SALTON SEA UNIT 6

CURE DATA REQUESTS SET FOUR (# 276 - 358)

Figure 1 Fault Tree of Non-Condensable Gas Pipeline

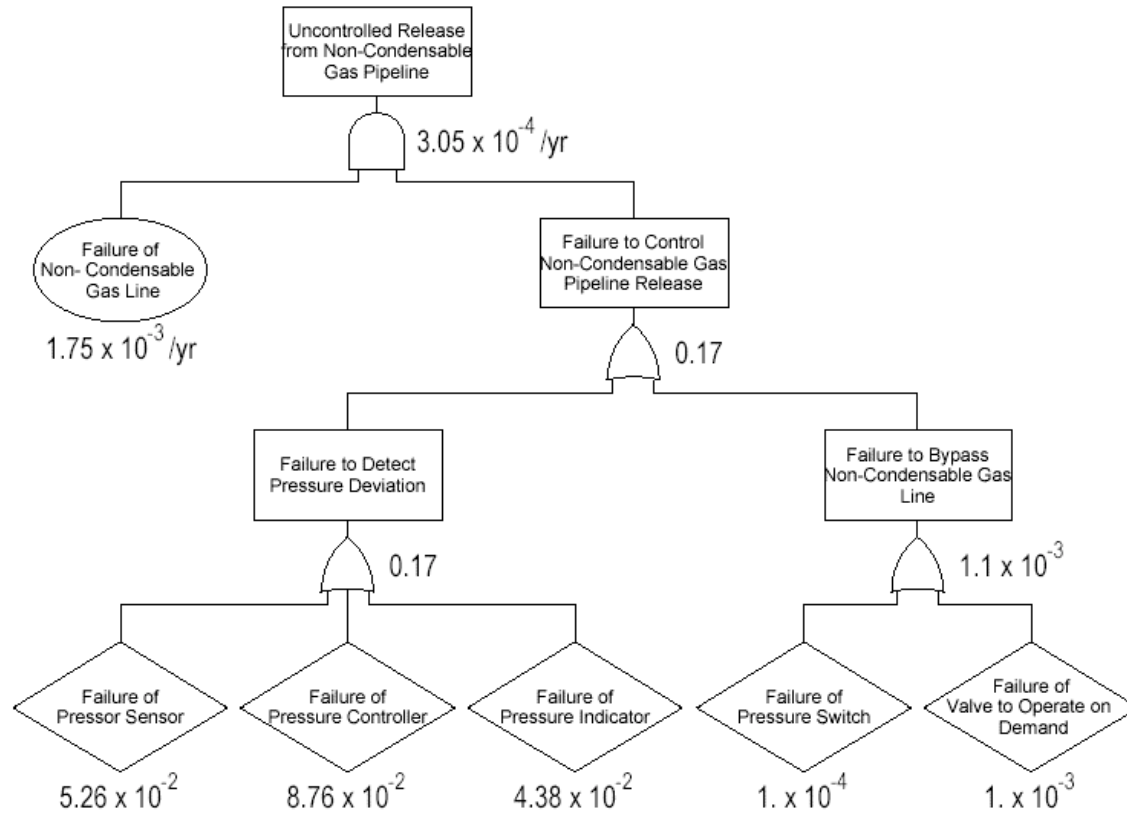
358. The AFC does not provide a complete analysis for facility-upset conditions upstream of the hydrogen sulfide (H₂S) control equipment. Uncontrolled steam (containing high concentrations of gases such as H₂S and ammonia (NH₃) releases are not uncommon at geothermal power facilities, whether from emergency relief venting or equipment failure.

Response to CEC Data Request 51 contained an analysis of one potential upset condition. This particular release scenario does not represent a potential worst-case release as it relies on active mitigation (pressure detection and a bypass valve) to minimize the duration of the release to less than one minute. As shown in Figure 1, there is a relatively high probability that the active safety system would fail on demand.

The Environmental Protection Agency (EPA) under the Risk Management Program (RMP) allows only passive mitigation measures (e.g., dikes, physical vapor barriers, etc.) to be considered, while active mitigation measures (i.e., those systems that rely on automatic detection and control) are assumed to fail. As shown in Figure 1, the automatic bypass system would have approximately a 17 percent chance of failing on demand, just based on the failure rates for the main system components. The actual failure probability could be higher as more components are considered in the fault tree analysis.
